GTR No. 9 – Draft proposal for Amendment 2

Note: The text reproduced below was prepared by the chairman of the informal working group on the global technical regulation No. 9 (Pedestrian safety)-Phase 2 proposing the use of a flexible pedestrian lower legform impactor in the global technical regulation No. 9 (pedestrian safety) - Phase 2. The modifications to the current text of gtr No. 9 on pedestrian safety are marked in bold for new or strikethrough for deleted characters. Text in square brackets is still under discussion and consideration of the informal group.

I. Proposal

Figure 25 Flexible lower legform impactor test set-up for tibia in static certification test
(see paragraph 8.1.1.4.)

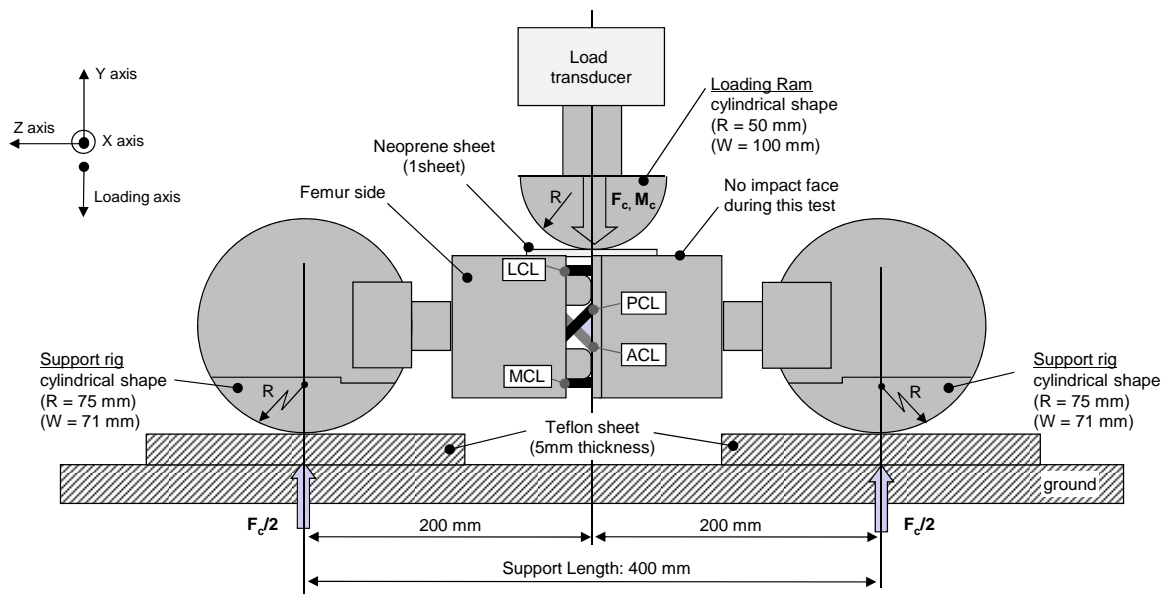
8.1.1.4. **The edges of the femur and tibia, not bending parts, shall be mounted to the support rig firmly as shown in Figure 24 and Figure 25. The Y-axis of the impactor shall be parallel to the loading axis within $180 \pm 2^\circ$ tolerance. In order to avoid friction errors, roller plates shall be set underneath the support rigs.**

Figure 26 Flexible lower legform impactor test set-up for knee joint in static certification test (see paragraph 8.1.1.5.)

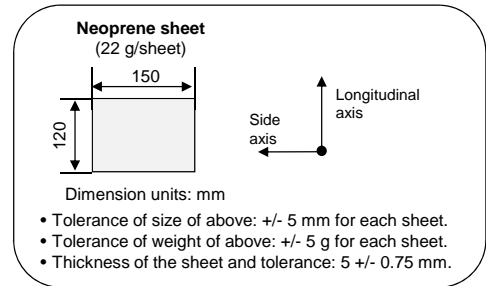
8.1.1.5. **The edges of the knee joint, not bending parts, shall be mounted to the support rig firmly as shown in Figure 26. The Y-axis of the impactor shall be parallel to the loading axis within $180 \pm 2^\circ$. In order to avoid friction errors, roller plates shall be set underneath the support rigs. To avoid impactor damage, a neoprene sheet shall be set underneath the loading ram and the impactor face of the knee joint which is described in the Figure 13 shall be removed. The neoprene sheet used in this test shall have compression characteristics as shown in Figure 15.**

The centre of the loading force shall be applied at the centre of the knee joint within $\pm 2^\circ$ tolerance along the Z-axis. The external load shall be increased at a rate between 10 and 100 mm/minute until the bending moment at the centre part of the knee joint (M_c) reaches 400 Nm.

Figure 27 Flexible lower legform impactor test set-up for dynamic lower legform impactor certification test, pendulum type (see paragraph 8.1.2.4.)

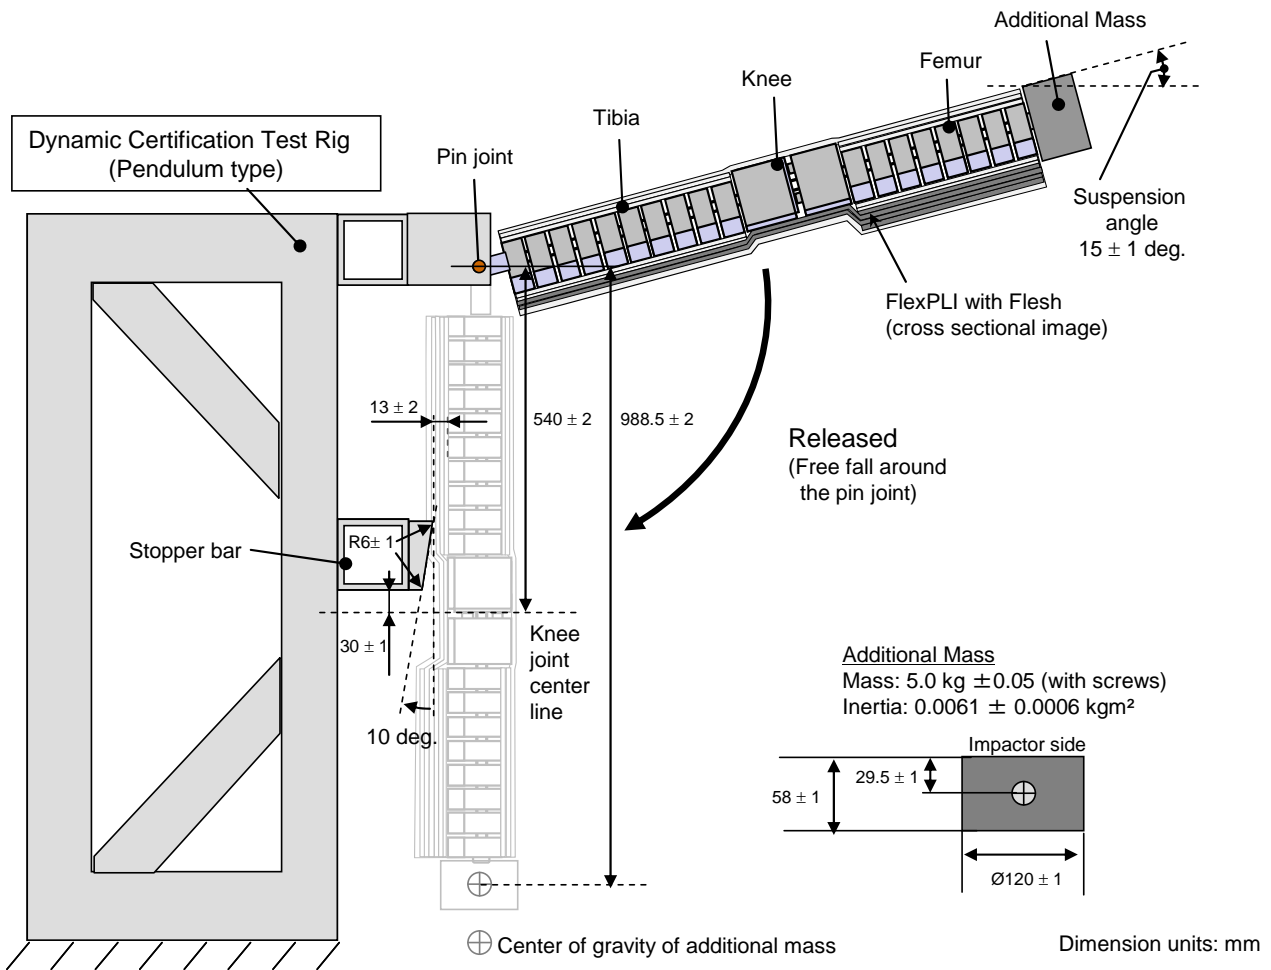
- 8.1.2.4.1. **The flexible lower legform impactor, including flesh, shall be suspended from the dynamic certification test rig $15 \pm 1^\circ$ upward from the horizontal as shown in Figure 27. The impactor shall be released from the suspended position, whereupon the impactor falls freely against the pin joint of the test rig as shown in Figure 27.**

- 8.1.2.4.2. **The knee joint centre of the impactor shall be 30 ± 1 mm below the bottom line of the stopper bar, and the tibia impact face without flesh shall be located 13 ± 2 mm from the front upper edge of the stopper bar when the impactor is hanging freely as shown in Figure 27.**

Figure 28 Flexible lower legform impactor test set-up for dynamic lower legform impactor certification test, inverse type (see paragraph 8.1.3.4.)

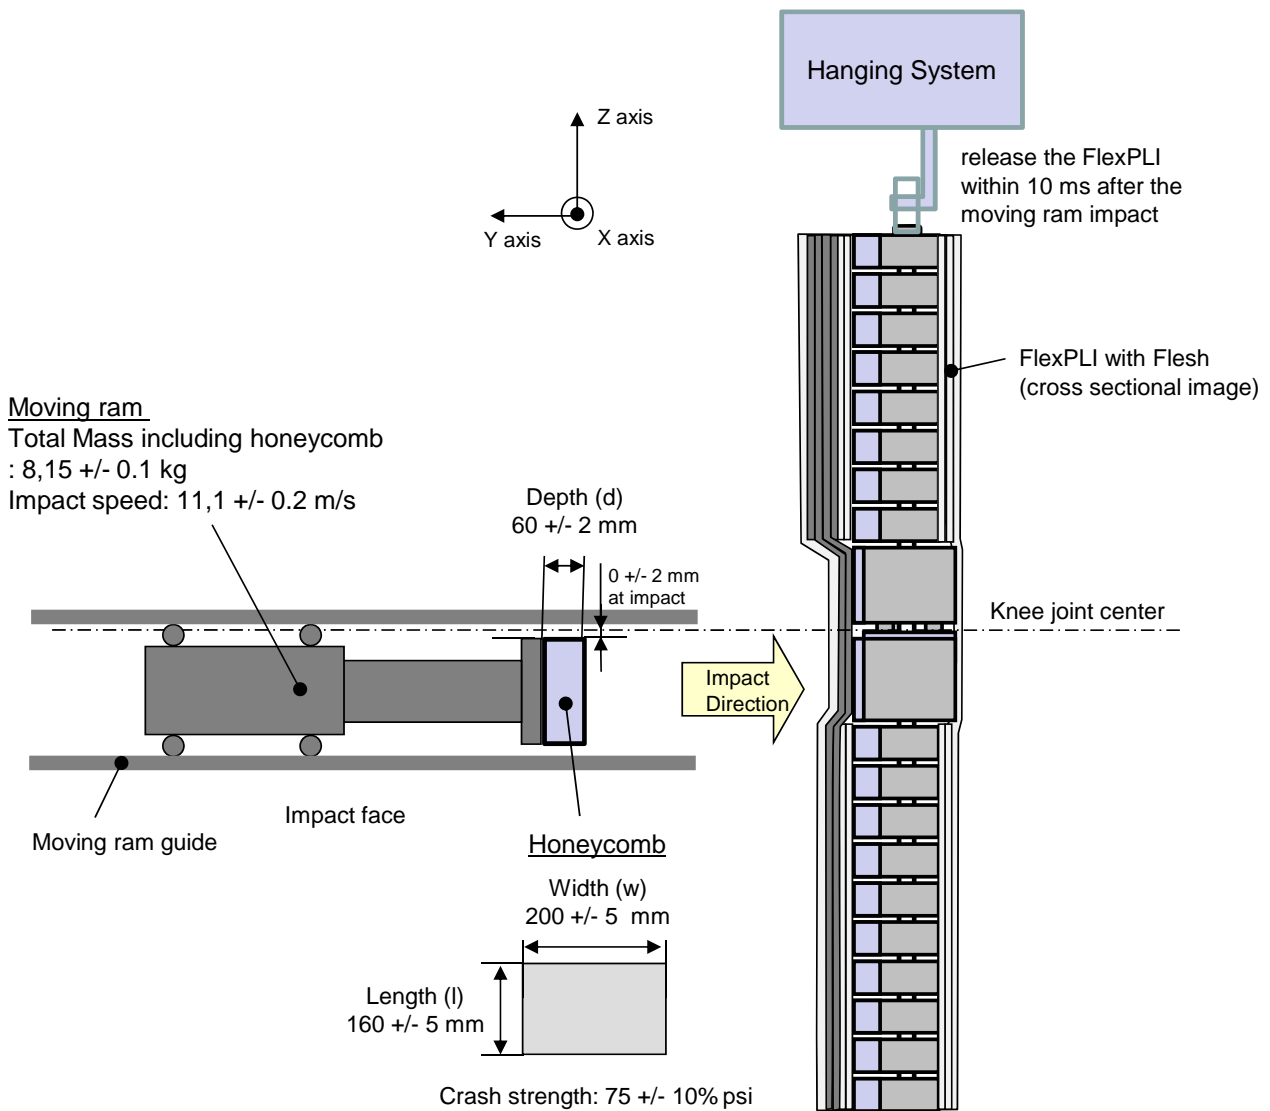
8.1.3.4.1. The fully assembled flexible lower legform impactor (with flesh and skin) shall be stationary suspended vertically from a test rig as shown in Figure 28. It is then impacted by the upper edge of a linearly guided Al honeycomb impactor, covered by a thin (less than 1 mm thickness) paper cloth, at an impact speed of $11,1 \pm 0,2$ m/s. The legform is to be released from the test rig within 10 ms after the time of first contact to ensure a free flight condition.

- 8.1.3.4.3.** The upper edge of the honeycomb face is to be in line with the rigid plate of the linearly guided impactor. At the time of first contact, the upper edge of the honeycomb is to be in line with the knee joint centre line within a vertical tolerance of 0 ± 2 mm. The honeycomb shall not be deformed before the impact test.

- 8.1.3.4.4.** The flexible lower legform impactor pitch angle and therefore the pitch angle of the velocity vector of the honeycomb impactor (rotation around Y-axis) at the time of first contact shall be within a tolerance of $0 \pm 2^\circ$ in relation to the lateral vertical plane. The flexible lower legform impactor roll angle and therefore the roll angle of the honeycomb impactor (rotation around X-axis) at the time of first contact shall be within a tolerance of $0 \pm 2^\circ$ in relation to the longitudinal vertical plane. The flexible lower legform impactor yaw angle and therefore the yaw angle of the velocity vector of the honeycomb impactor (rotation around Z-axis) at the time of first contact shall be within a tolerance of $0 \pm 2^\circ$, to ensure a correct operation of the knee joint."
